CLAUSE 46 AND 49 TIMESTAMP PROPOSAL FOR UPSTREAM EPoC

Authors: Mark Laubach

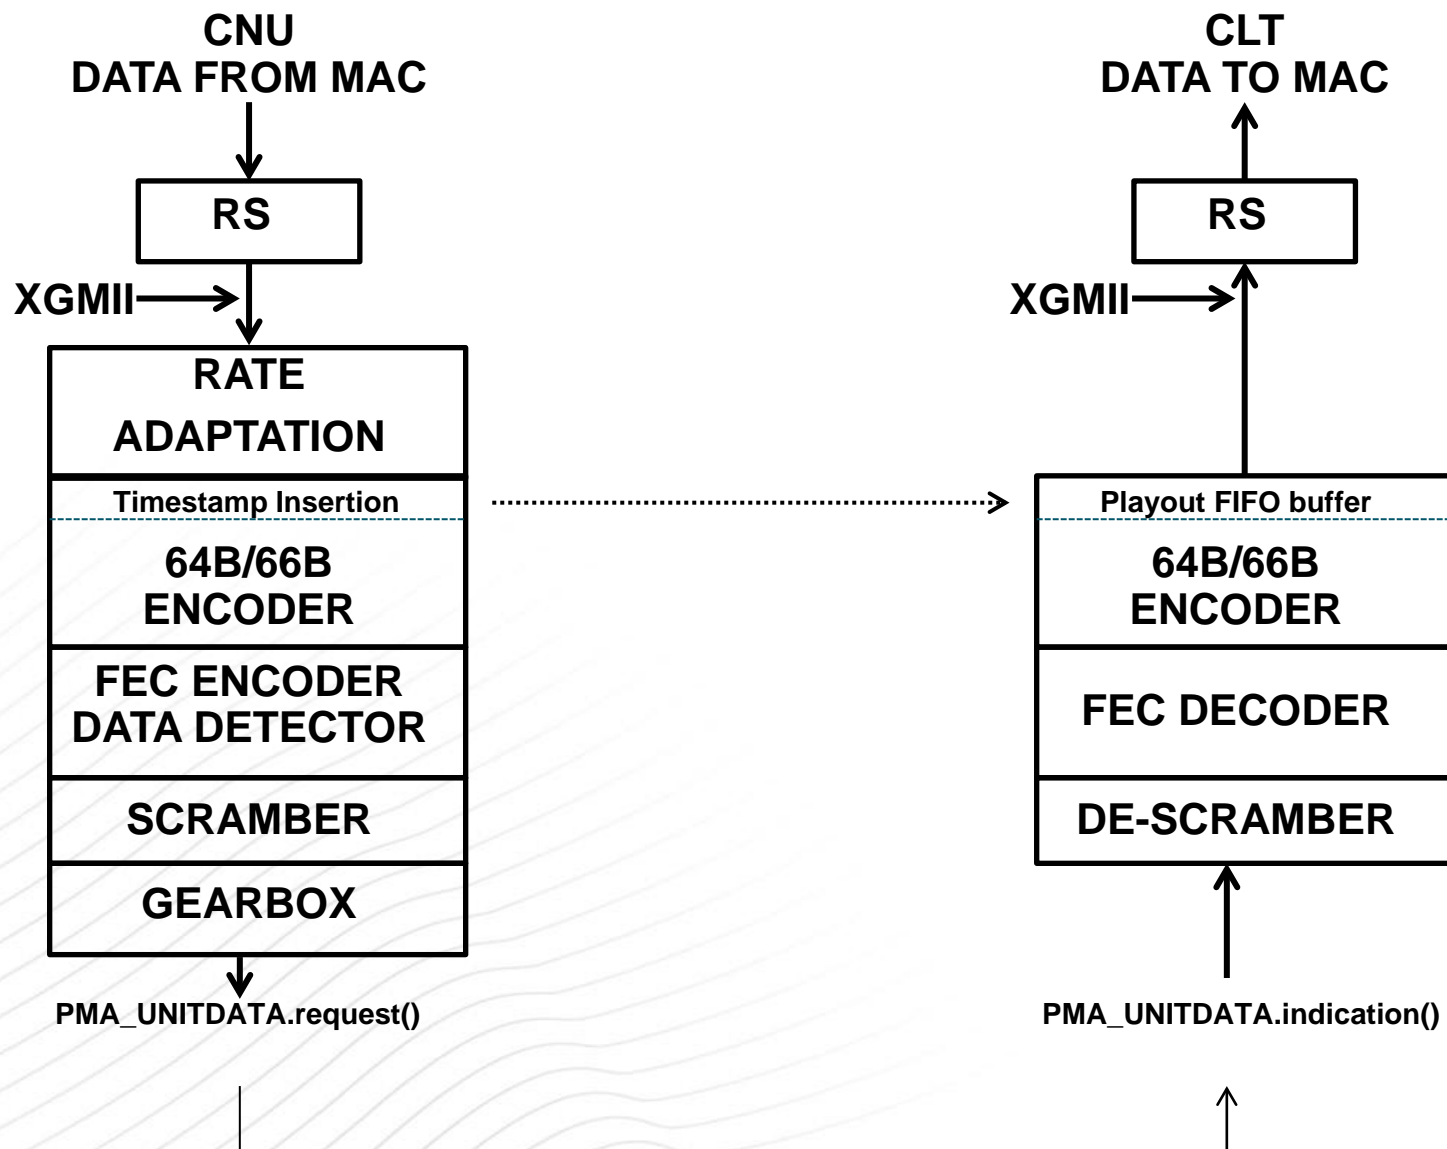
- In table 46-3 for TXD and TXC, changing a reserved value of “FC” for use as Start, with timestamp.
- In table 46-4 for RXD and RXC, changing a reserved value of “FC” for use as Start, with timestamp.

The above is simply to reserve the value of “FC” for use in Clause 49.

- **In Figure 49-7, add new Control block format for 0xfc**
 - $Q_0Q_1Q_2Q_3D_0D_1D_2$
 - Where Q code is an octet, four octets for a timestamp
 - Intent is for 64b/66b line encoding to signal that for a Start, data is preceded by a 32-bit timestamp.

- **Table 49-1, add new row**
 - “start with timestamp”, /S+/, 0xfc, Start followed by 32-bit timestamp value
- **Add new section 49.2.4.12:**
 - 49.2.4.12 Start with timestamp (/S+/
For EPoC PHY use (Clause 101). In the CNU transmitter (upstream), upon receiving a valid start control character (/S/) as per Section 49.2.4.8 at the beginning of an upstream burst, the EPoC 64B/66B encoder will change the block type value from 0xfb to 0xfc, insert the timestamp value in octets $Q_0Q_1Q_2Q_3$ and construct the block payload as per Figure 49-7. In the CLT receiver, if a block type value of 0xfc (/S+) is received, the EPoC 64B/66B decoder will treat this as equivalent to 0xfb, change the value to 0xfb (/S/), and will not include the timestamp octets in the decoded MAC frame.
